*PLANS FOR THE CONSTRUCTION OF
SEDIMENT REMOVAL
FOR
VITRUVIAN PARK
TOWN OF ADDISON, TEXAS
PUBLIC WORKS #19-77*

VITRUVIAN PARK
 DREDGING
 TOWN OF ADDISON
 DALLAS COUNTY, TEXAS

revisions	date
1 ADDENDUM 3	2/20/2019

MAIN CHANNEL CROSS SECTIONS					Sheet No.
design	drawn	checked	scale	date	15
NDM	NDM	NDM	NDM	2/20/19	22
NDM job number					18-005

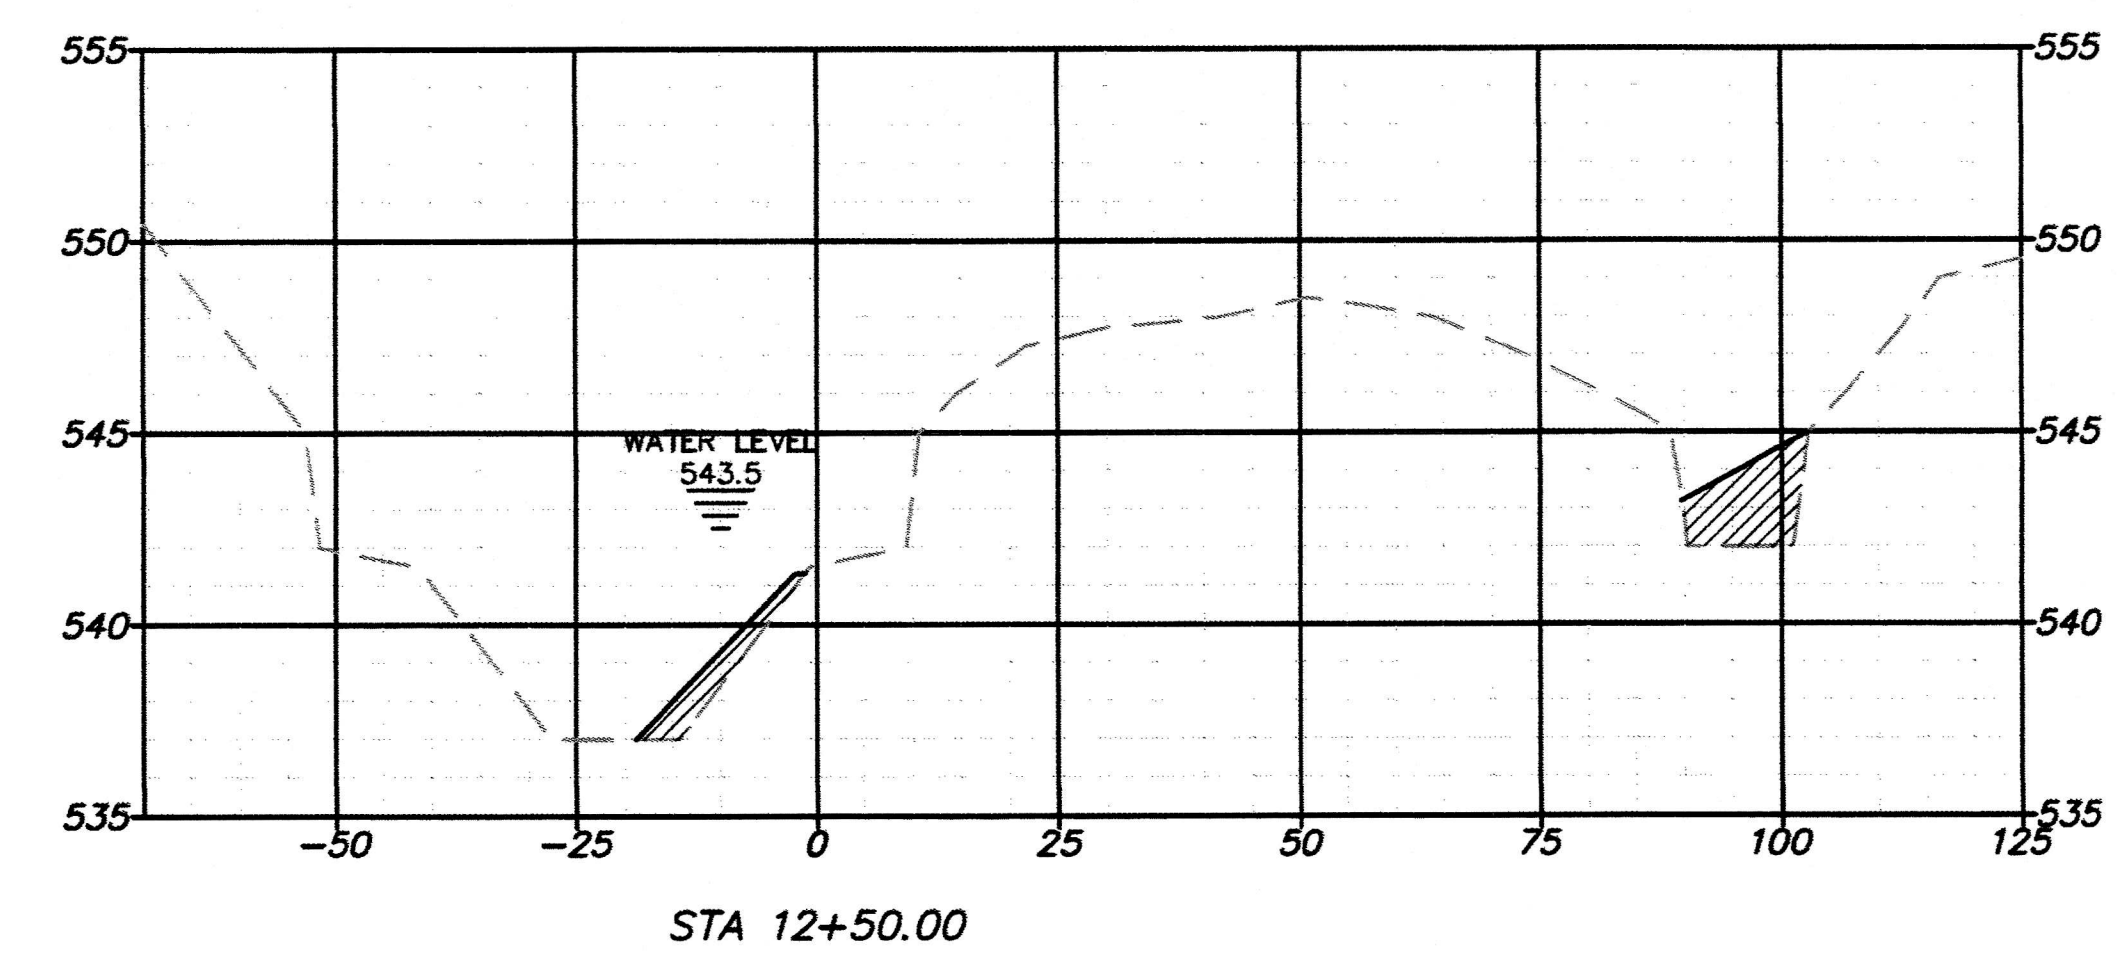
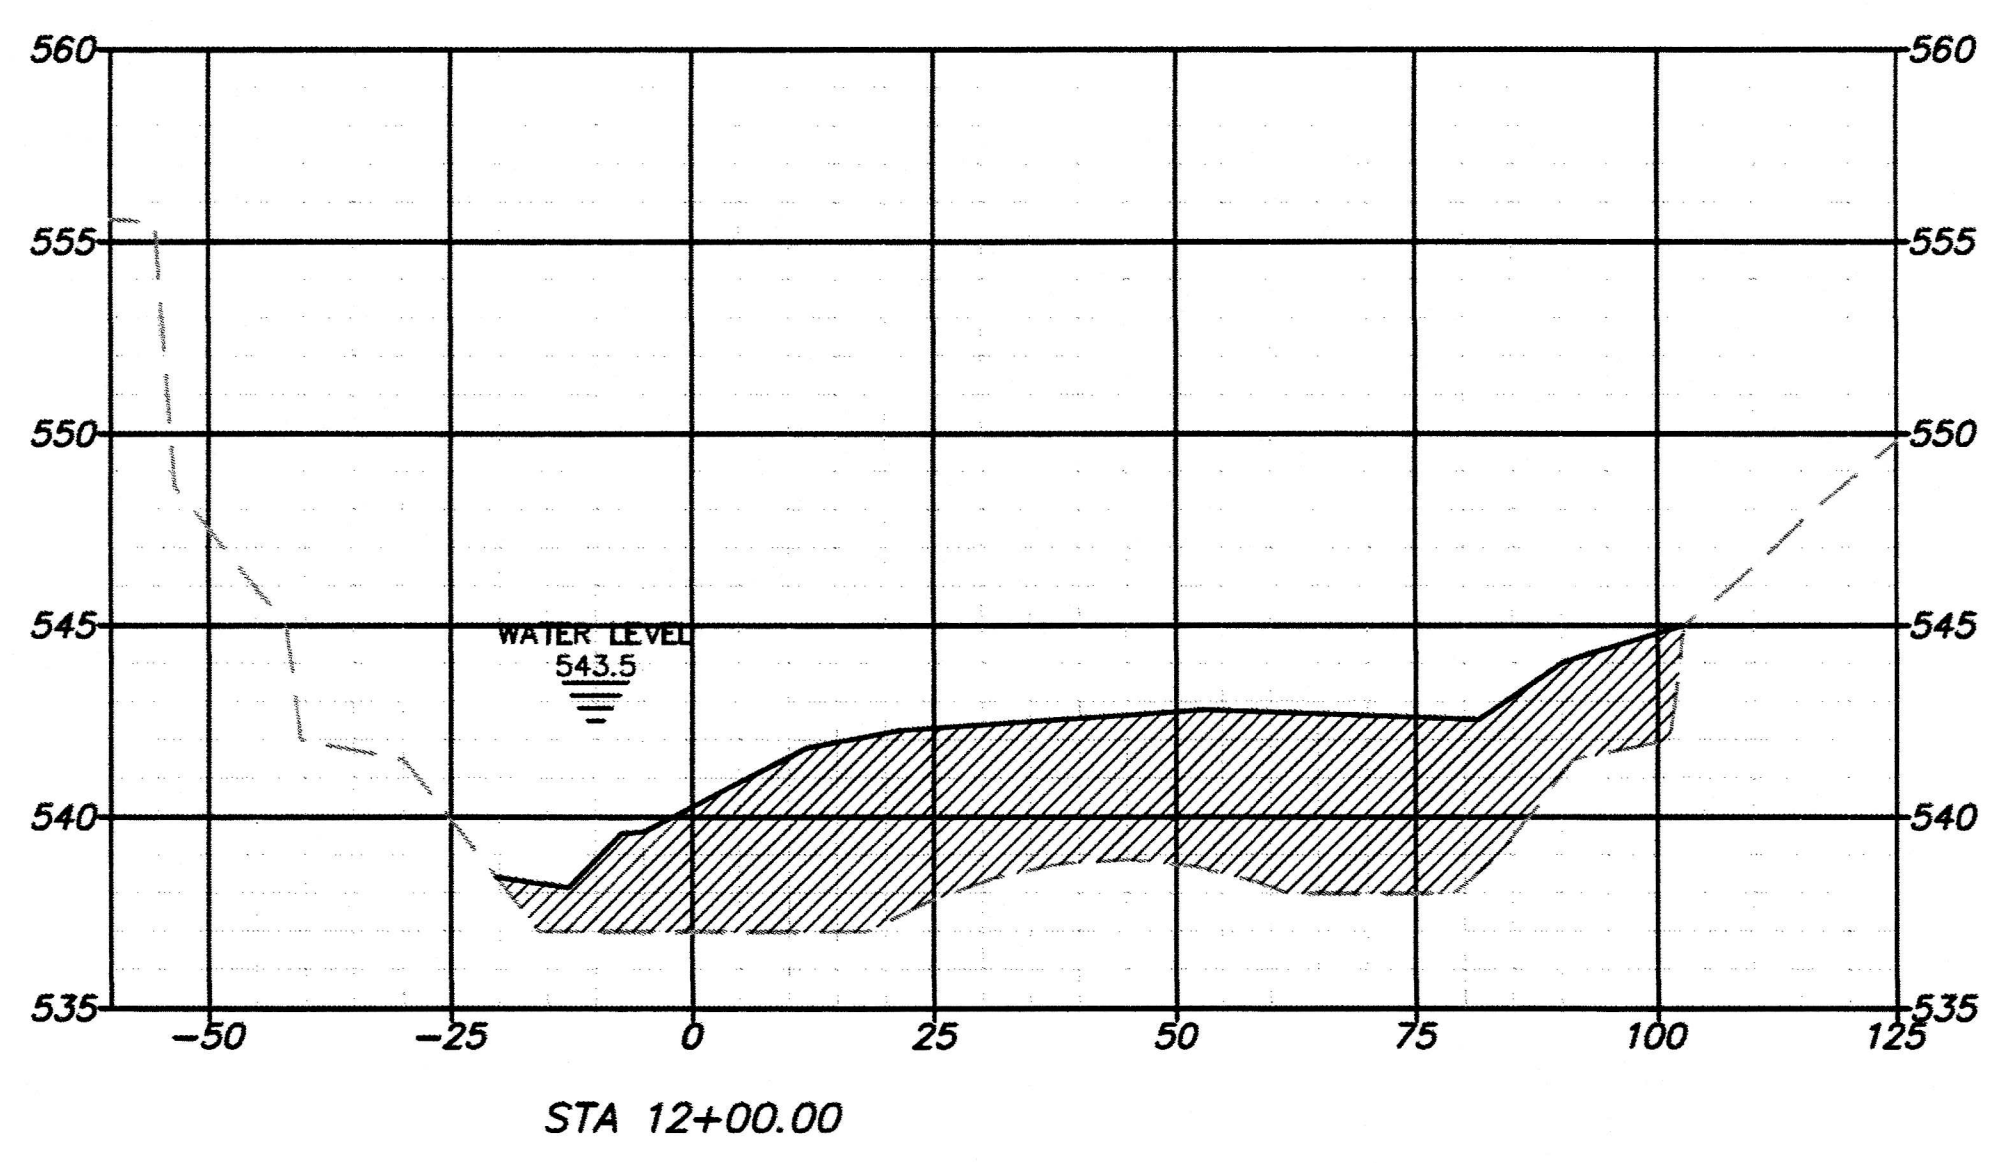
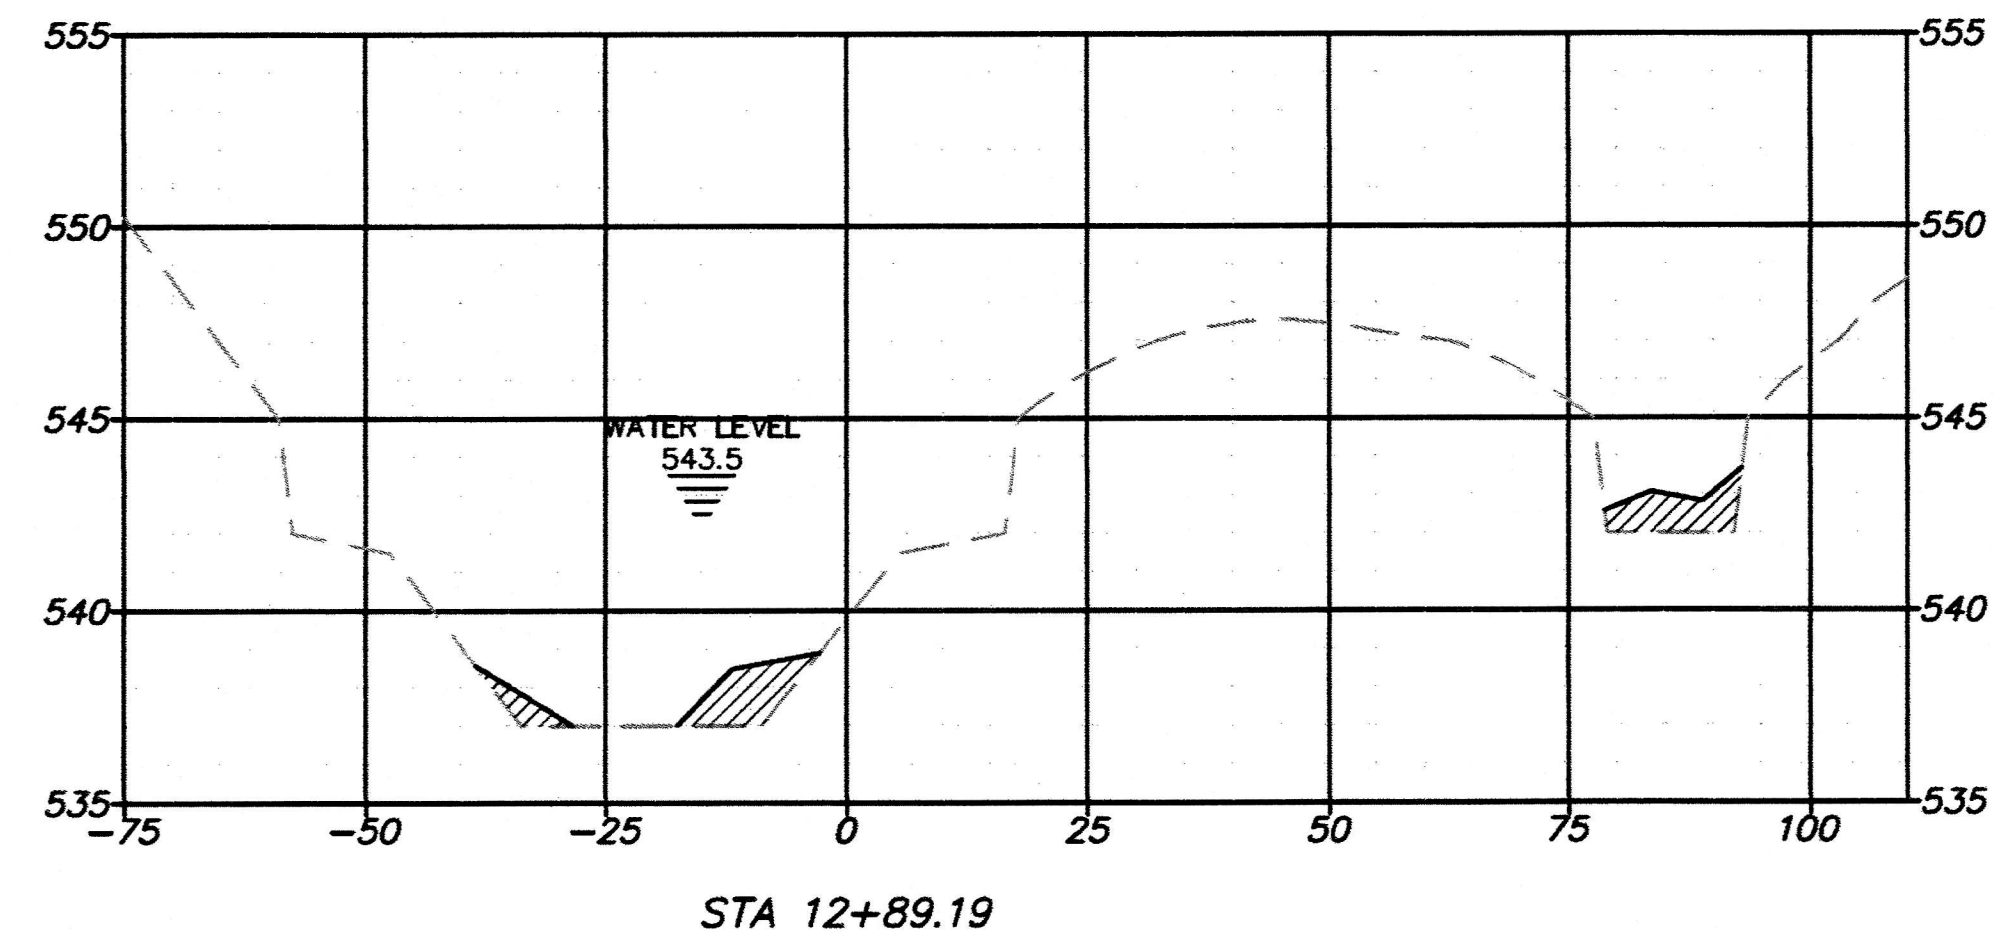
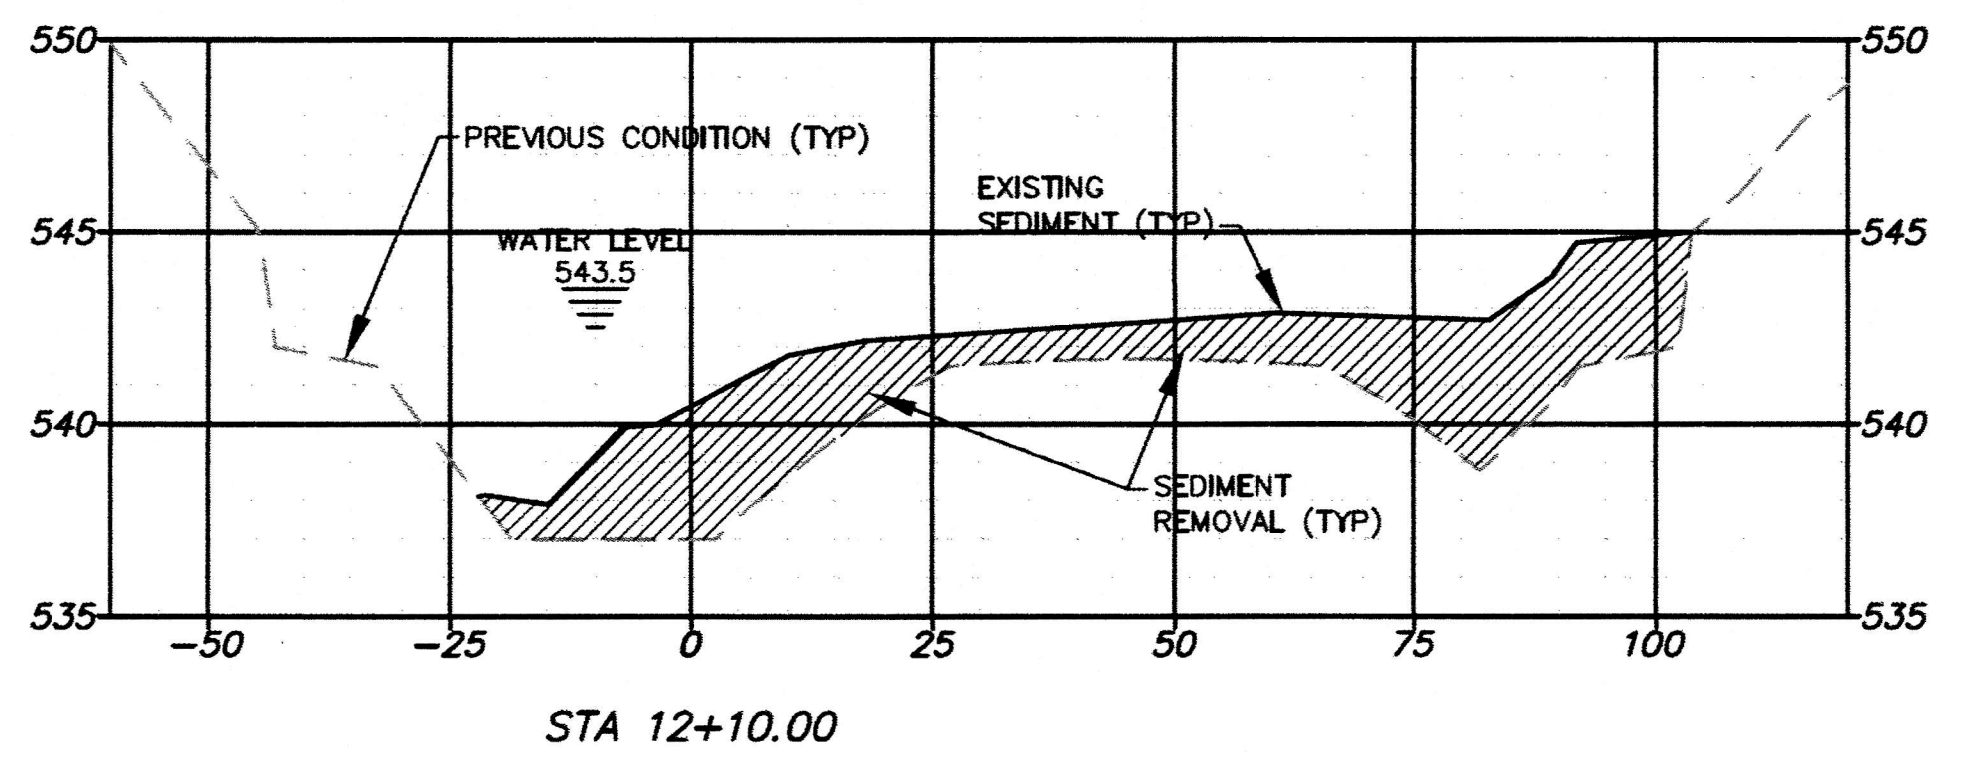
▲ WATER SURFACE ADDED BASED ON SURVEY OF 2/18/2019.
